# UNITED STATES PATENT AND TRADEMARK OFFICE

10/534,848

<b>Office Action Summary</b>	<b>Application No.</b> 10/534,848	<b>Applicant(s)</b> METAYER ET AL.	
	<b>Examiner</b> BLAINE G. NEWAY	<b>Art Unit</b> 4133

**DETAILED ACTION**

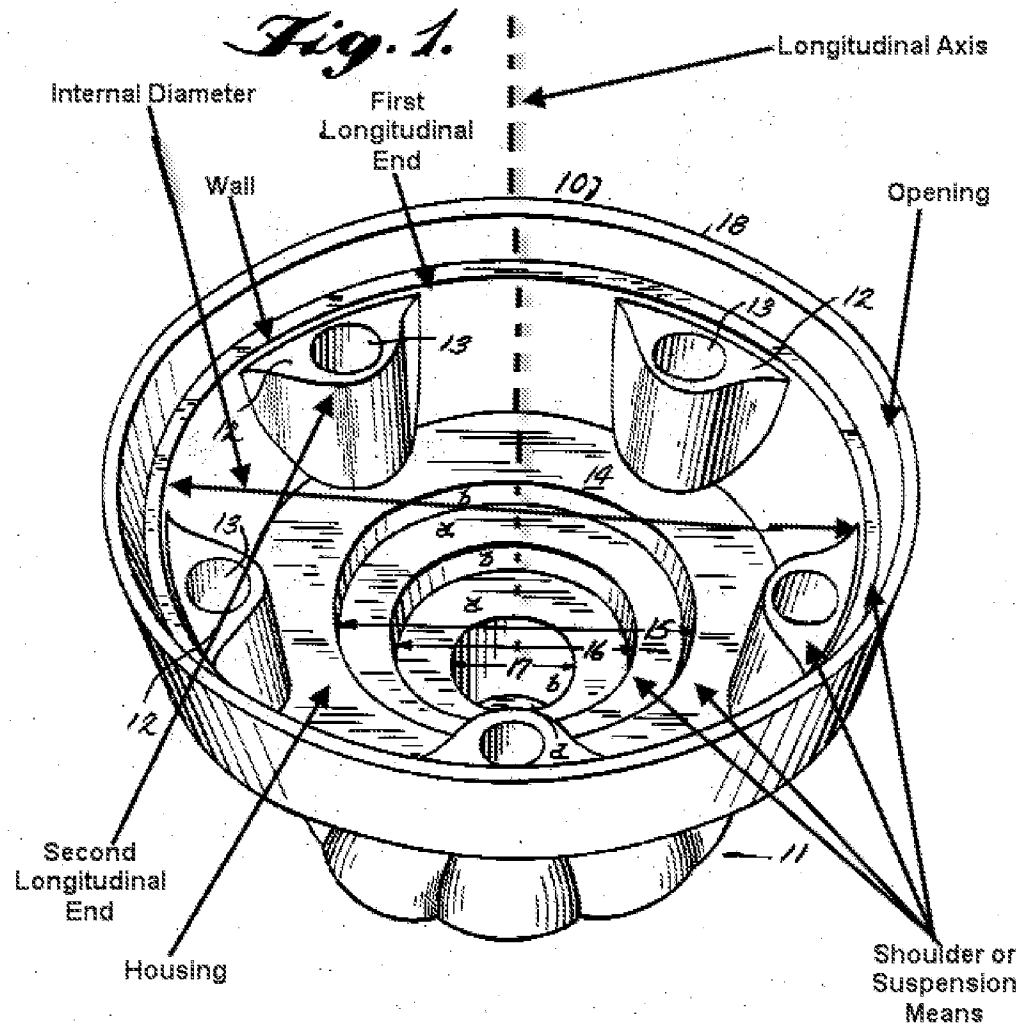
a wall connecting the first longitudinal end to a second longitudinal end;  
at least one suspension means or shoulder made in the wall so that a non-zero distance separates the shoulder and a first or second face of the appropriately sized brake disc, facing towards the second longitudinal end of the housing (See marked up figure 1).

Regarding claim 2, Fenton further discloses the suspension means or the shoulder (of width such that the shoulder collaborates with a radially external end of a first or second face of an appropriately sized brake disc) connecting a larger-diameter first cylindrical portion of the longitudinal axis (of a diameter greater than the diameter of the appropriately sized brake disc) and a smaller-diameter second portion of the longitudinal axis (see marked up figure 1).

Regarding claim 3, Fenton further discloses the shoulder being made of at least two parts arranged in one and the same plane and formed by angular sectors distributed, advantageously uniformly, over the periphery of the housing (see marked up figure 1).

Regarding claim 4, Fenton further discloses the housing having several shoulders arranged in parallel planes so that the storage element is capable of taking brake discs of different diameters (see marked up figure 1).

Regarding claim 5, Fenton further discloses each shoulder connecting a larger-diameter part to a smaller-diameter part, and the smaller-diameter part forming the next larger-diameter part, and in that each larger-diameter part has an axial dimension along the longitudinal axis capable of being at least equal to half the distance separating first and second faces of an appropriately sized brake disc (see marked up figure 1).

Regarding claim 6, Fenton further discloses the smaller-diameter portion of the suspension means along the longitudinal axis from the first longitudinal end of the housing towards the second longitudinal end forms the larger-diameter portion of a next suspension means (see marked up figure 1).
